APPLICATION NO.	FILING DATE	FIRST NAMED INVENTOR	ATTORNEY DOCKET NO.	CONFIRMATION NO.
10/561,401	01/30/2006	Ilkka Naatti	TAMPPAT-17	1100
36528 STIENNON &	7590 03/20/200 STIENNON	EXAMINER		
612 W. MAIN ST., SUITE 201			CAMPOS, JR, JUAN J	
P.O. BOX 1667 MADISON, WI 53701-1667			ART UNIT	PAPER NUMBER
•			4136	
			MAIL DATE	DELIVERY MODE
			03/20/2008	PAPER

Application No.	Applicant(s)		
	10/561,401	NAATTI ET AL.		
Office Action Summary	Examiner	Art Unit		
	Juan J. Campos	4136		
The MAILING DATE of this communication app Period for Reply	pears on the cover sheet with the c	orrespondence address		
A SHORTENED STATUTORY PERIOD FOR REPL' WHICHEVER IS LONGER, FROM THE MAILING Do - Extensions of time may be available under the provisions of 37 CFR 1.1 after SIX (6) MONTHS from the mailing date of this communication. - If NO period for reply is specified above, the maximum statutory period v - Failure to reply within the set or extended period for reply will, by statute Any reply received by the Office later than three months after the mailing earned patent term adjustment. See 37 CFR 1.704(b).	ATE OF THIS COMMUNICATION 36(a). In no event, however, may a reply be tin will apply and will exp

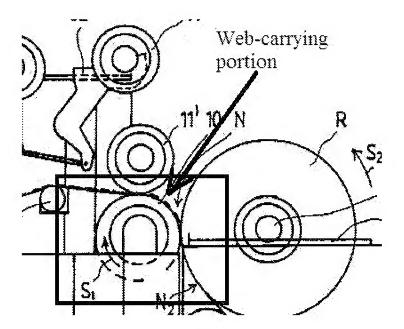
Regarding claims 27-28, Kinnunen et al. discloses a device for reeling a paper or board web into reels around rotation reel spools 11 (or reeling cores), see figures 1-5 and column 6, lines 10-16. Kinnunen et al. discloses a two carrier guide rails 12 (or transfer device) movable in the machine direction for transferring the reel spools (or reeling cores) and a reel forming around it during secondary reeling (figures 1-5) where the paper web W is guided continuously to the reel via a reeling nip N (later N₂ and N₃), see figures 1-5. Kinnunen et al. also shows transfer members 32 (or device for transferring) transferring a new reel spool 11' (or new empty reeling core) with an edge (or periphery) to the stand-by position (or change station), assumed to be the location of spool 11", where the paper web W guided to the reel in the secondary reeling (see N₃ in figure 4) is changed to travel to the edge of and around the new reel spool 11' (see figure 5). Additionally, Kinnunen et al. discloses that the rests and revolves in its reeling positions, e.g., on two carrier rails 12 (see column 6, lines 16-18). The two carrier rails are also considered a device for keeping the new reel spool (or new reeling core) in a primary reeling station (the area next to reeling cylinder 10) where the paper web is guided around the new reel spool through a reeling nip, N. Kinnunen et al. discloses a loop of belt F (or support member) where there is a web-carrying portion traveling in a travel direction (see figure below) with portion forming the reeling nip of secondary reeling (see N₂) and with the carrier rails (or transfer device) being arranged to transfer the reel R in the secondary reeling so secondary reeling moves in the travel direction of web-carrying portion. Kinnunen et al. also shows a guide roll 21 (or first guide roll) inside the loop of the belt F having an axis being located in the travel direction of the support

member (see figure 1) in the beginning of the web- carrying portion (the area near the reeling cylinder 10) forming the reeling nip of secondary reeling (N₂ or N₃), see figures 1-5. In addition, Kinnunen et al. shows that the first guide roll being arranged movable in the direction of the edge (or periphery) of the reeling spool in the primary reeling station (the area next to reeling cylinder 10) so that the distance of the reeling nip between the reeling spool and the loop of the belt F from the first guide roll changes (see right side of figures 1-5). As the reeling spool 10 is reeled, and as the paper web is being wound around the spool, the distance of the nip between the spool and belt changes. As can be seen from figures 1-5, the axis of the guide roll (the roll disclosed by Kinnunen et al is assumed to have an axis) is movable linearly at least in the machine direction.

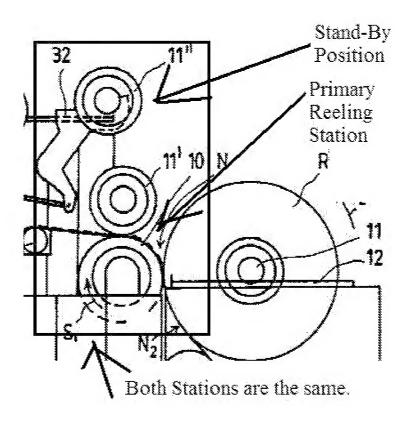
Regarding claims 30-31, Kinnunen et al. discloses a stand-by position (or change station), assumed to be the location of spool 11", and primary reeling station (the area next to reeling cylinder 10). From reviewing figures 1-5, and figure provided below, the stand-by position and primary reeling station are considered the same and implemented by the reeling

cylinder (10) which is arranged to keep the new reel spool (using the carrier rails 12) in both the stand-by position and primary reeling station.
